City Council Memorandum

To: Mayor Fasbender and City Council
From: John Hinzman, Community Development Director
Date: November 7, 2022
Item: Extend Siewert Apartment Approvals - Preliminary Plat, Final Plat, and Site Plan

**Item: Siewert Apartments - Rezoning, Preliminary Plat, Final Plat, and Site Plan #2021-34 -
River City Investments LLC**

SIEWERT APARTMENTS
 GRADING PLAN
 SHEET 1
 OF 1 SHEETS

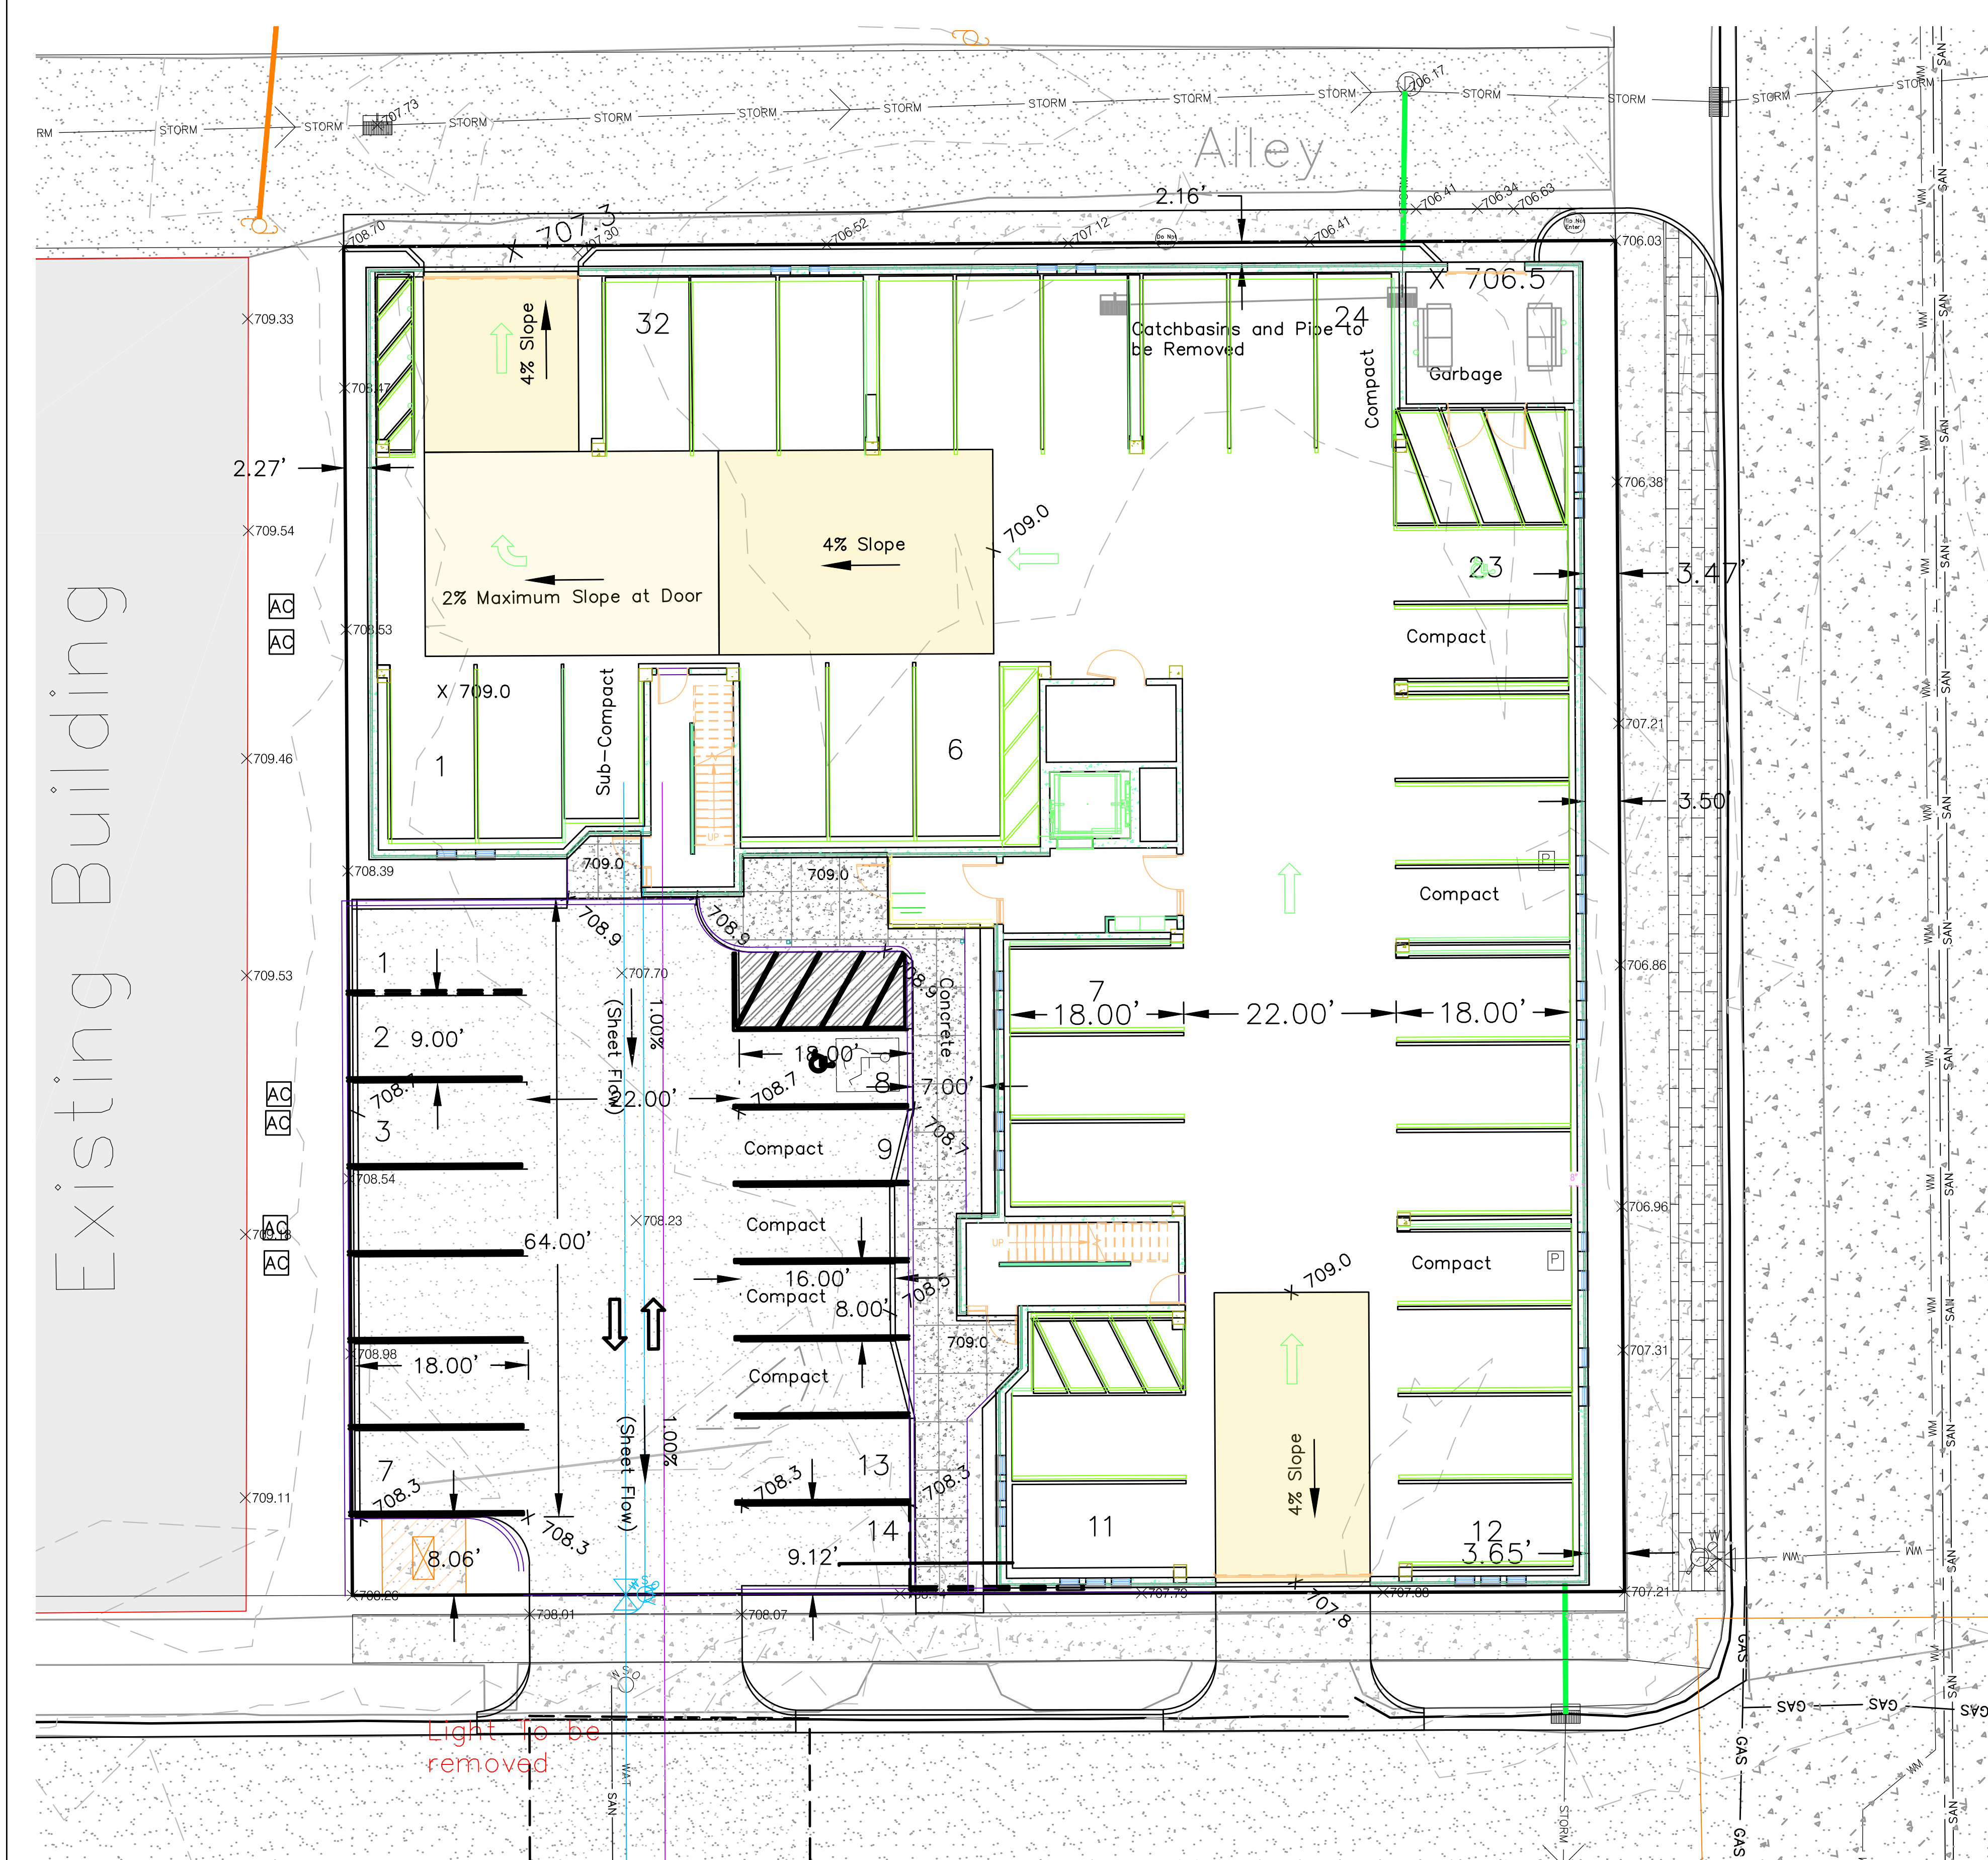
The Public Works Department is providing concurrent review of the Grading, Drainage, Erosion Control, and Utility Plans. Site Plan approval shall be conditioned upon final approval of the Grading, Drainage, Erosion Control and Utility Plan by the Public Works Director including resolution of the following:

1. Applicant must provide written confirmation for any work that will encroach onto neighboring private properties.
2. Utility plan must confirm that the existing utilities must be abandoned to the main line.
3. Utility plan must confirm the size of the new utility service lines and connections to each.
4. Gate valve must be placed at the property line.
5. Water service line must be split at the building exterior between domestic and fire suppression (each with a shut off valve).
6. Storm sewer design must be completed with connection details provided to public storm structures.

1 PLANTING PLAN
SCALE: 1" = 10'

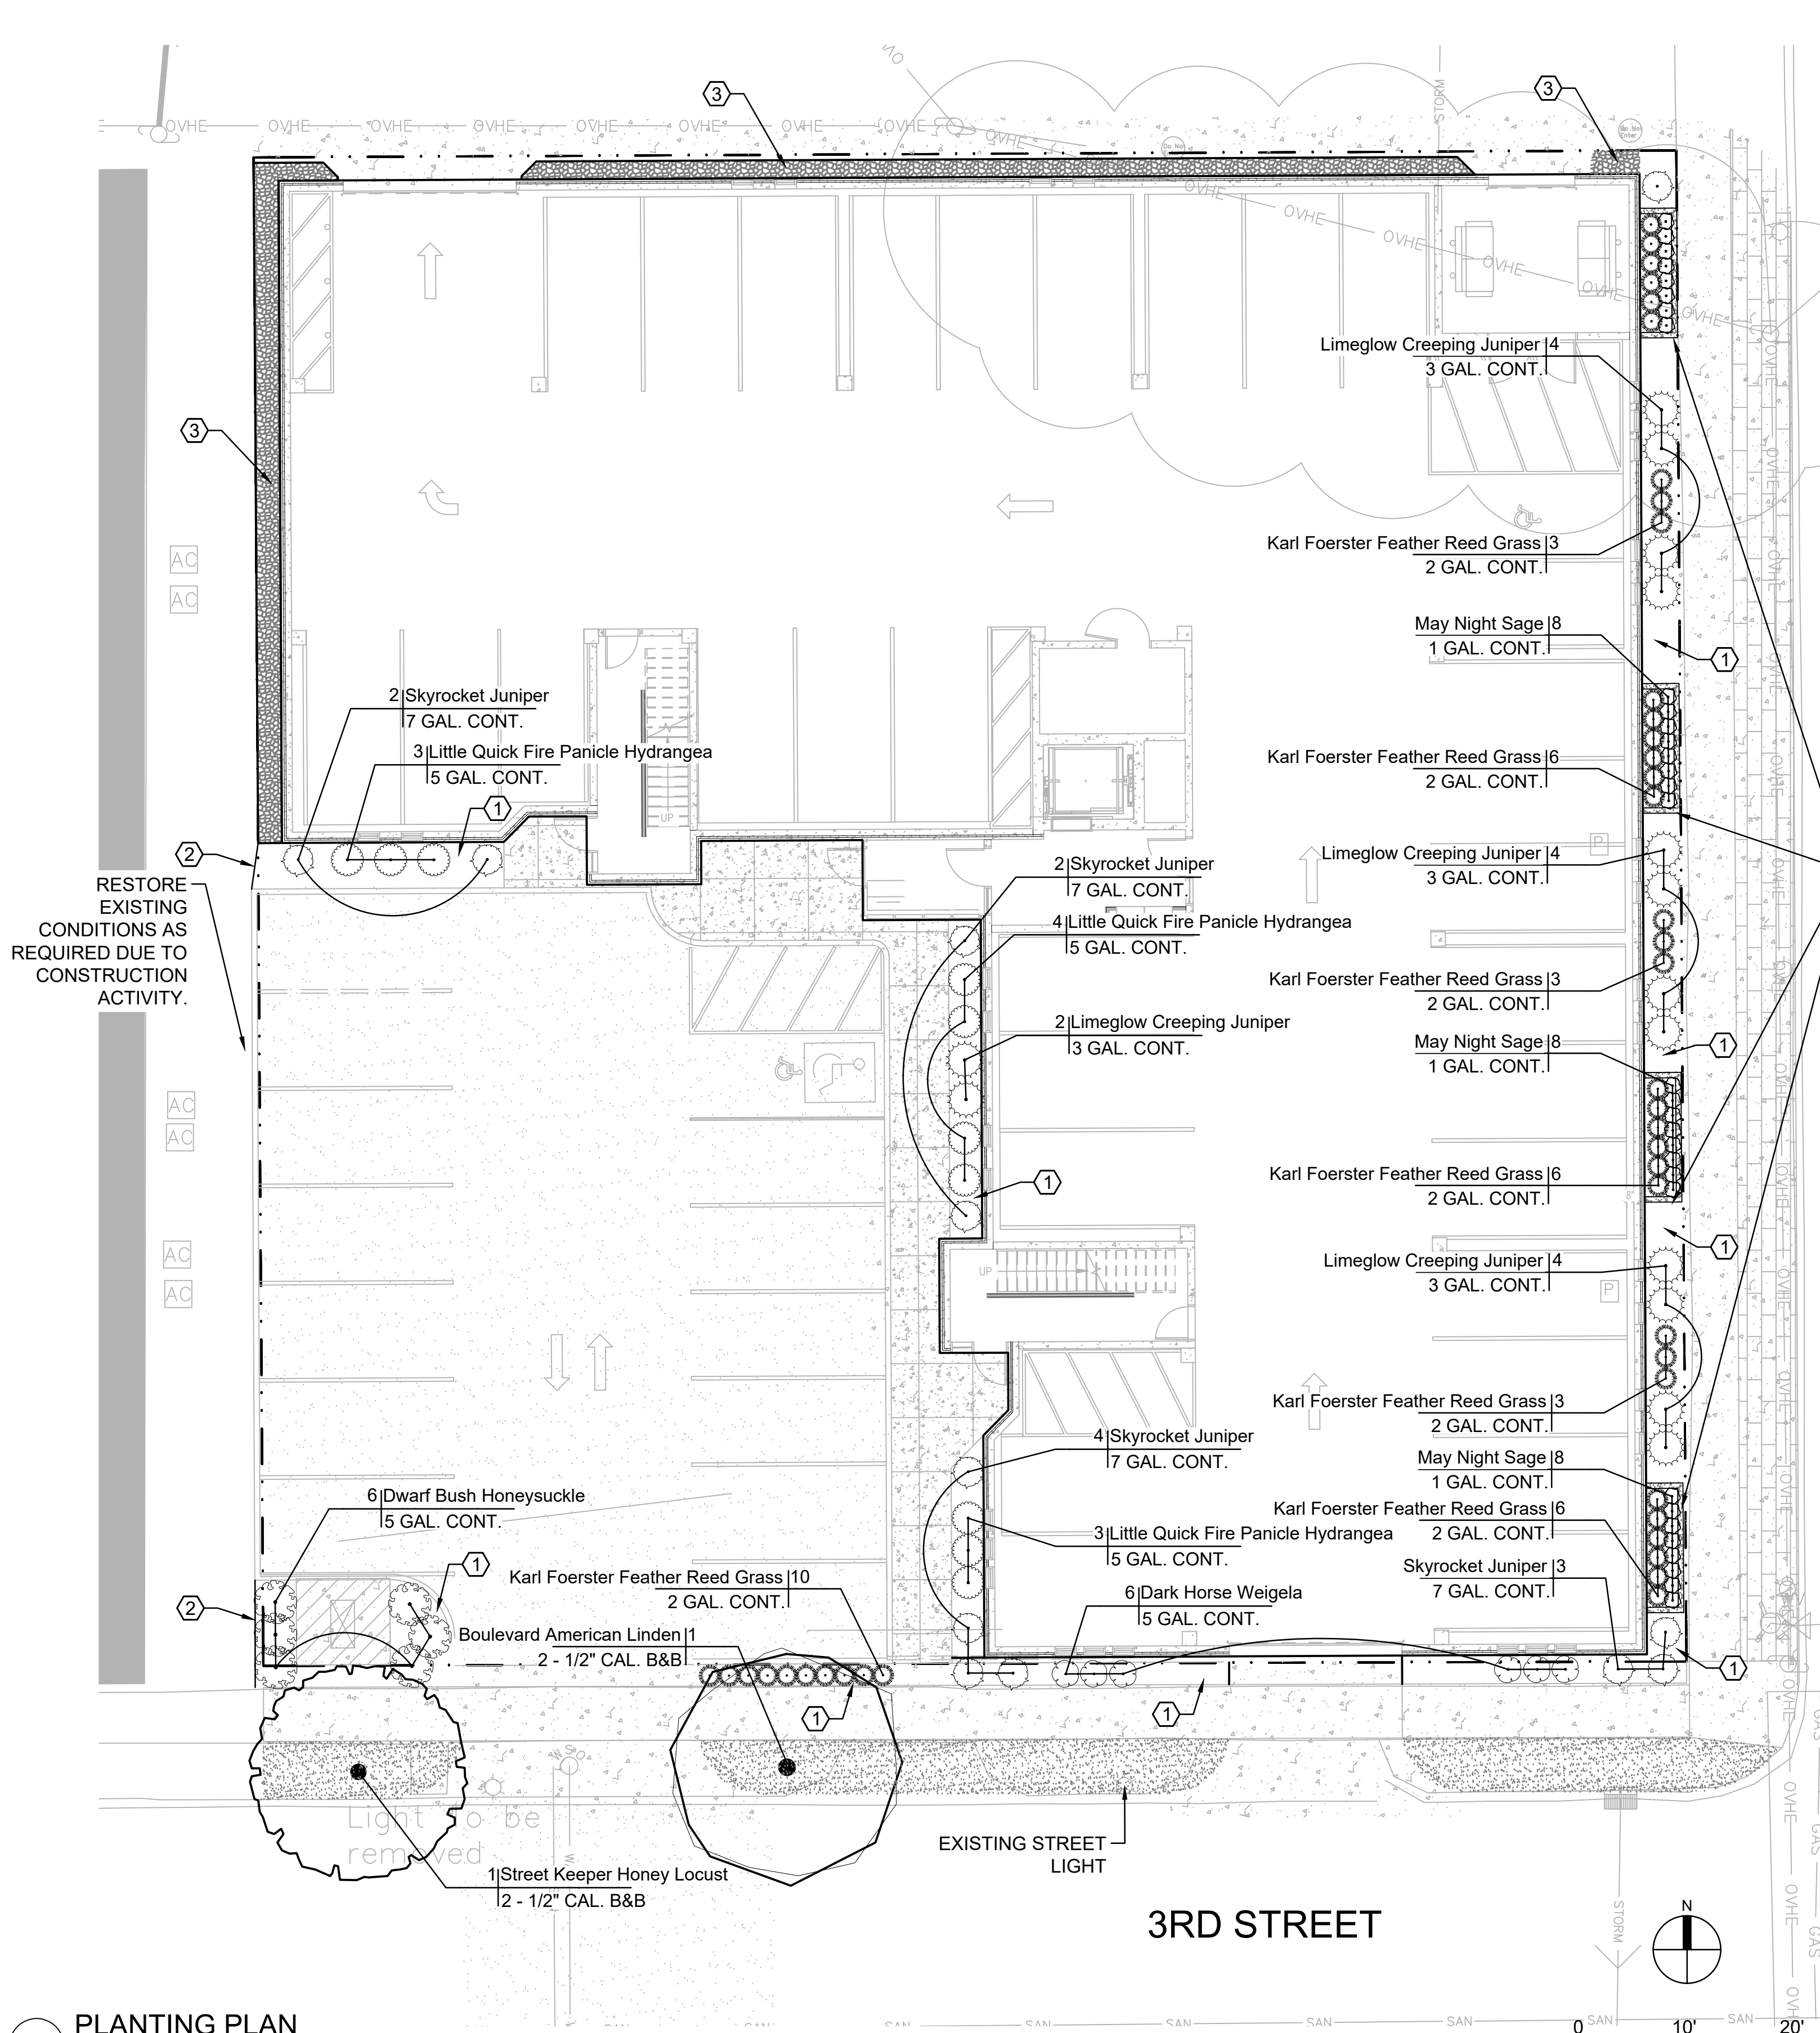
Landscaping is acceptable as presented. Development comprises the entire block with very limited yard spaces (similar to other downtown buildings). The landscape code provides flexibility for planting standards on constrained sites. The ability to plant trees within the property is limited, however the developer has exceeded minimum shrub plantings standards and incorporated raised planting beds along sidewalk areas. Landscaping is provided as follows:

Required	Proposed
One tree per 4,000 s.f. of paved surface – 4,600 s.f.	1.2 Trees	0 Trees
One tree per 50 feet of lot perimeter – 544 feet	10.9 Trees	2 Trees
One shrub per 40 feet of lot perimeter – 544 feet	13.6 shrubs	48 Shrubs
